## POLICY REPORT DEVELOPMENT AND BUILDING

Report Date: September 22, 2009  
Contact: Michelle McGuire  
Contact No.: 604.873. 7271  
RTS No.: 08246  
VanRIMS No.: 08-2000-20  
Meeting Date: October 6, 2009

SUBJECT: CD-1 Rezoning/Heritage Revitalization Agreement/Heritage Designation:  
3205-3221 West 41st Avenue and 5590 Balaclava Street

Knox United Church Site

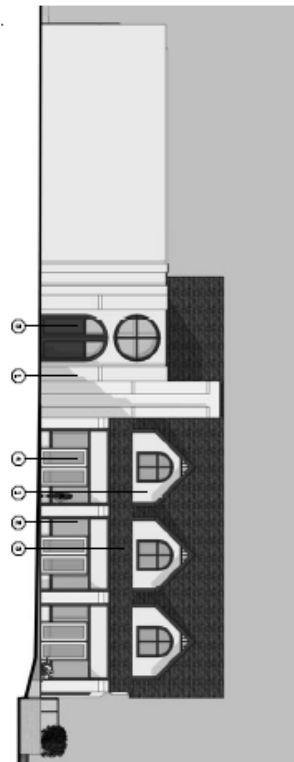
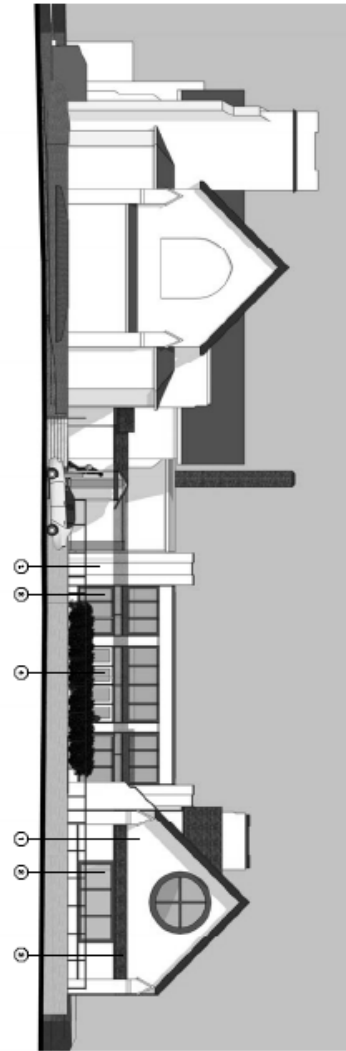
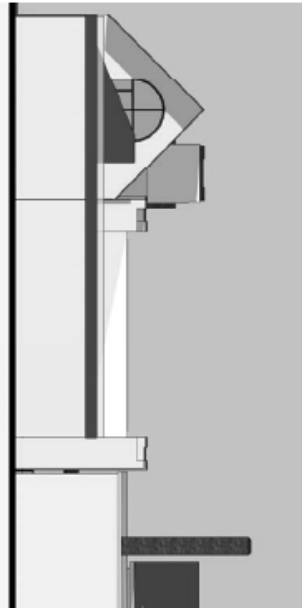
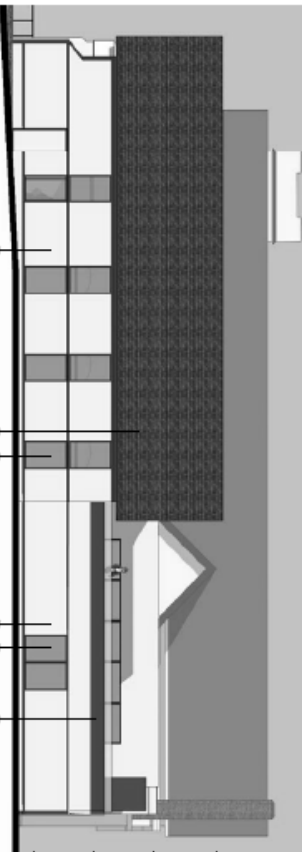
- (xi) Design development to the massing and location of the new church annex building to provide substantial improvement with regard to shadowing, privacy and visual impact on the neighbouring property to the north;

Note to Applicant: The two storey meeting space should be relocated and/ or the roof redesigned to minimize shadowing impact. Impact of the rooftop outdoor play area in the north east corner should also be minimized by pulling the building as far back as possible from the north property line as well as by employing planters or other screening which are not visually intrusive.

- (xvi) Design development to provide increased separation between the new church annex building from the existing Knox United Church;

The Panel was concerned that the addition to the church would depart from the historical aspect of the church unless the same quality of materials and workmanship were used. A couple of Panel members suggested the addition could look like it was built at the same time as the church while other members of the Panel thought it could be a contemporary addition that would add a further counterpoint to the neighbourhood.
